Inland Gas Upgrades (IGU) Project CPCN Application

Presentation and Q&A

July 10, 2019

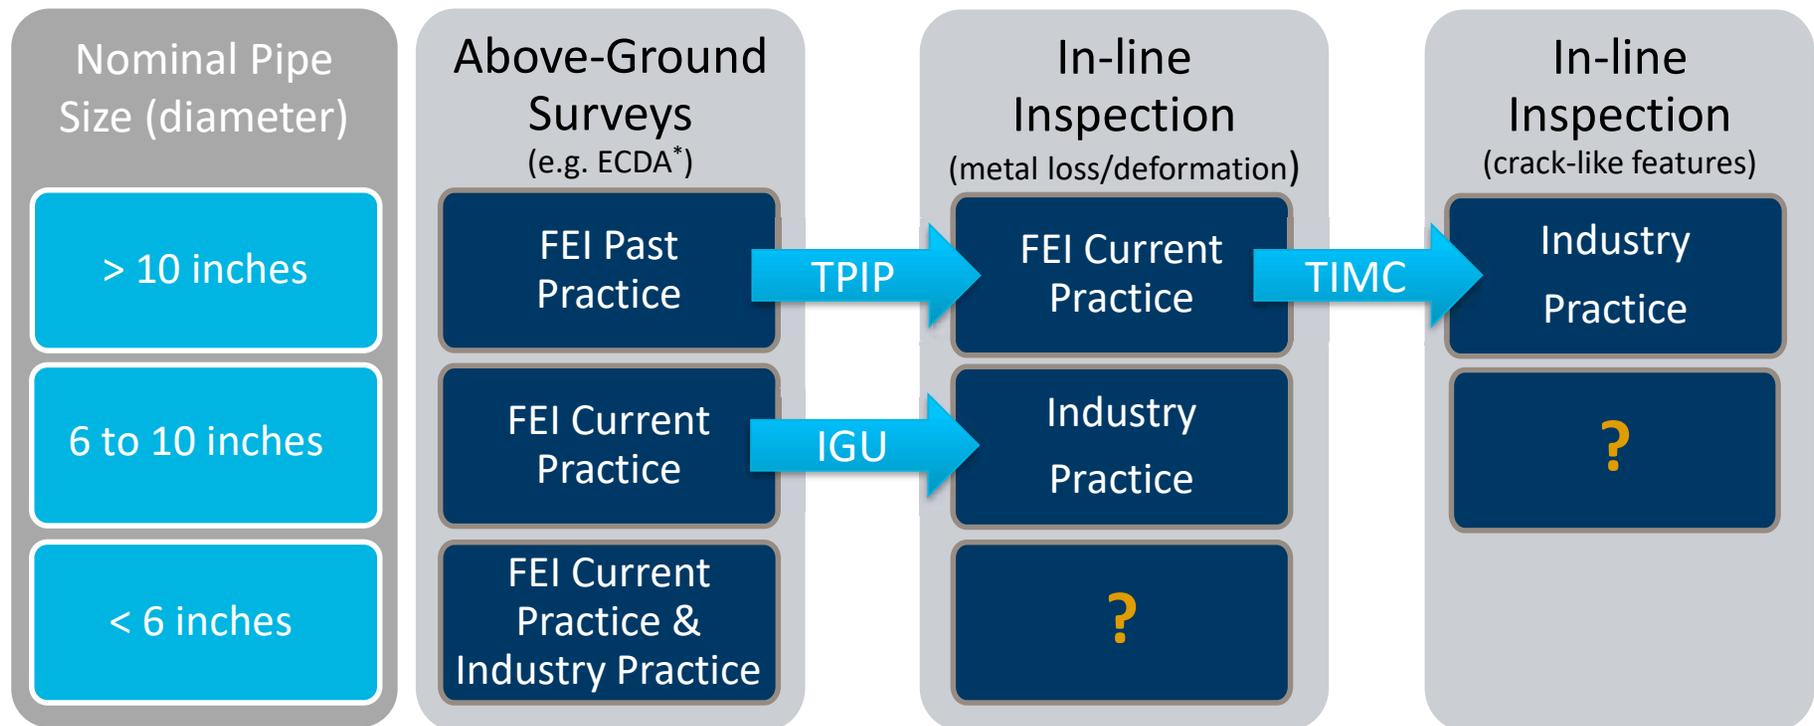
1. The BC Oil & Gas Commission (BC OGC) has found that FEI's existing risk assessment process requires corrective action, and that the corrective action encompasses all of FEI's pipeline assets in BC. Given the need for corrective action, the Panel is puzzled as to why it would be appropriate to proceed with the IGU project before such issues are resolved and a compliant risk assessment process is in place that could be applied to assessing the need and priority for the IGU project. In short, is it premature to proceed with the IGU project at this time?

➤ **FEI response: The Quantitative Risk Assessment (QRA) under development is not necessary to justify the IGU Project. Compliance with industry standard practice, and codes and regulation are sufficient to support the need for the IGU project.**

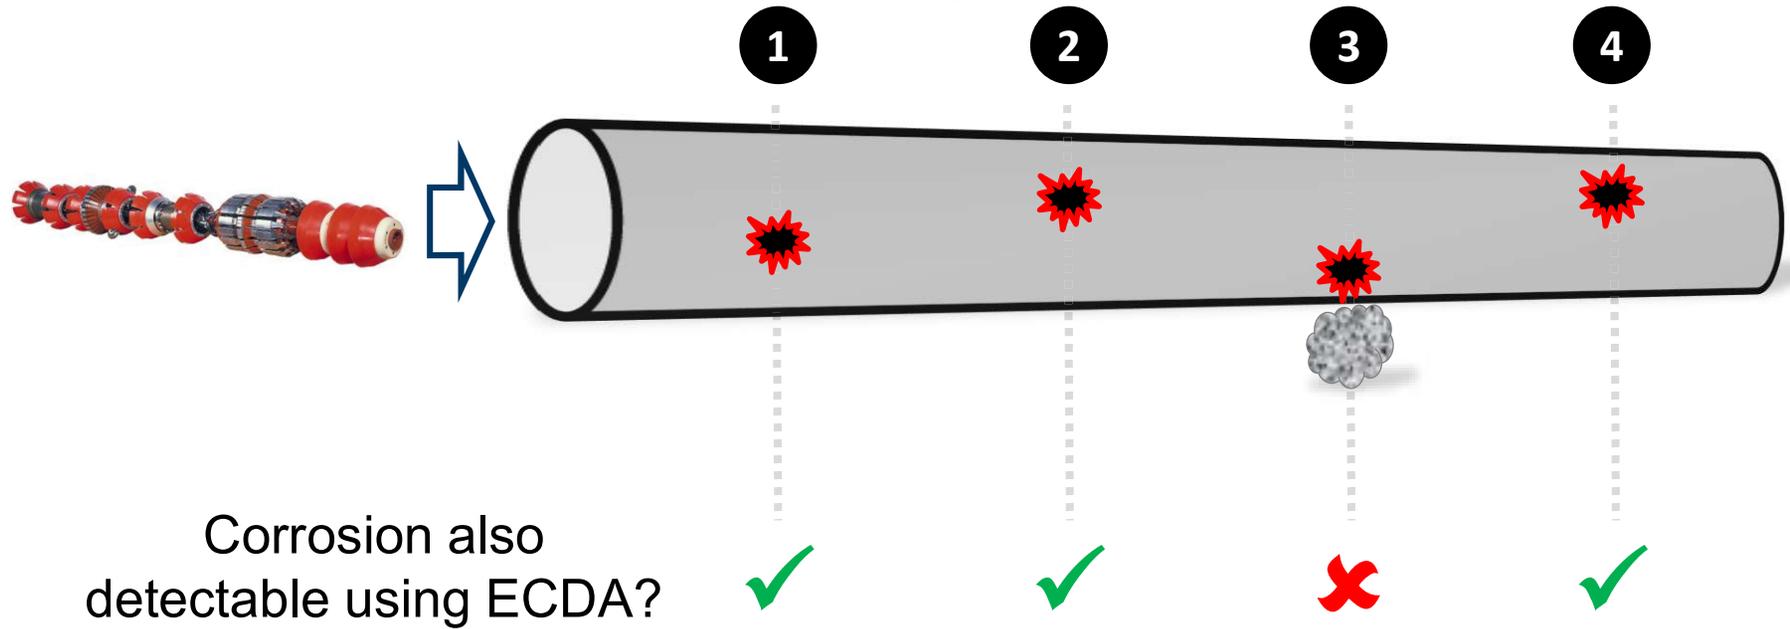
3. FEI states that it relied on data taken from in-line inspection driven integrity digs of other pipelines (i.e. not the 29 transmission laterals) to determine the need for the IGU project while also stating information from in-line inspection driven integrity digs could not be used to identify and prioritize potential corrosion locations on the 29 transmission laterals because the drivers that contribute to corrosion are unique to a specific site along a pipeline. The Panel is concerned that these two statements appear to be inconsistent.

- FEI has identified evidence of cathodic protection (CP) shielding on its transmission pipeline system - e.g. rocks, disbonded coating
 - ILI-driven digs have identified active corrosion on cathodically protected pipe

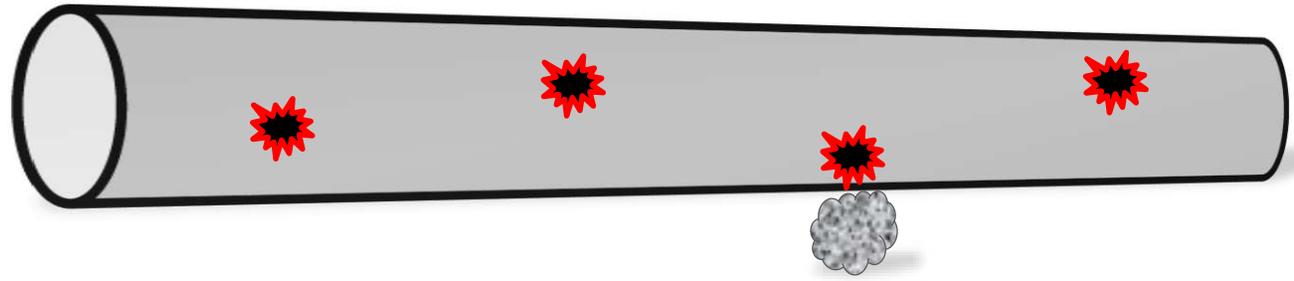
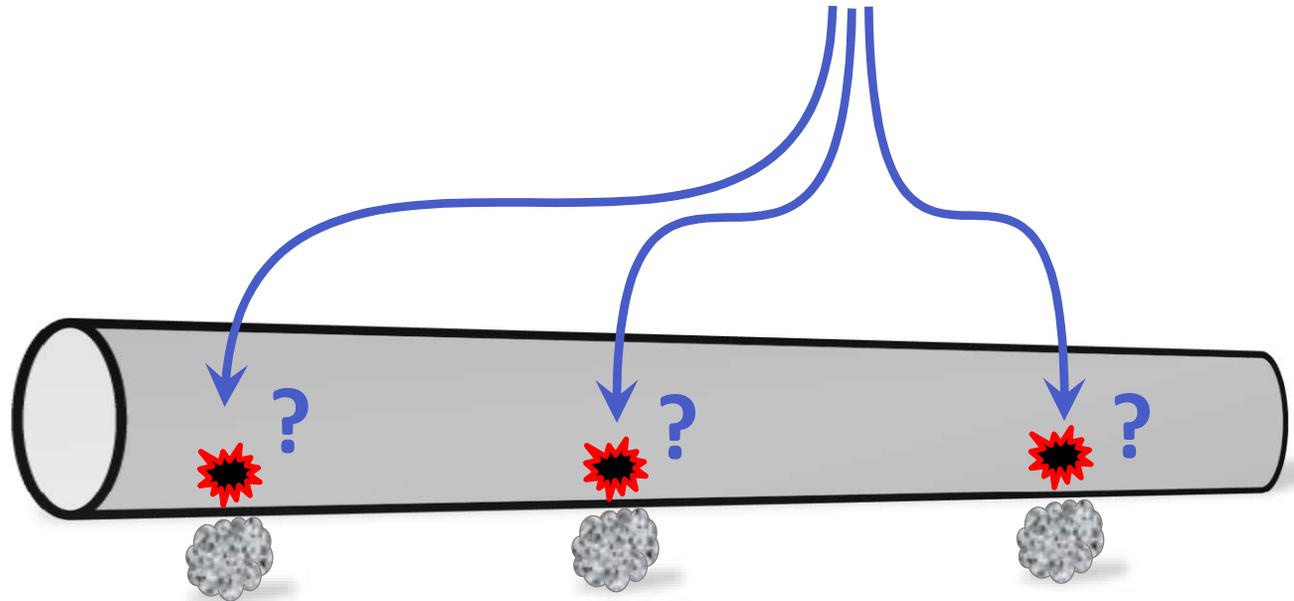
3. FEI states that it relied on data taken from in-line inspection driven integrity digs of other pipelines (i.e. not the 29 transmission laterals) to determine the need for the IGU project while also stating information from in-line inspection driven integrity digs could not be used to identify and prioritize potential corrosion locations on the 29 transmission laterals because the drivers that contribute to corrosion are unique to a specific site along a pipeline. The Panel is concerned that these two statements appear to be inconsistent.

- **FEI Response: Feature location information from pipeline A (ILI-inspected pipelines) does not inform the location of features on pipeline B (the IGU pipelines).**
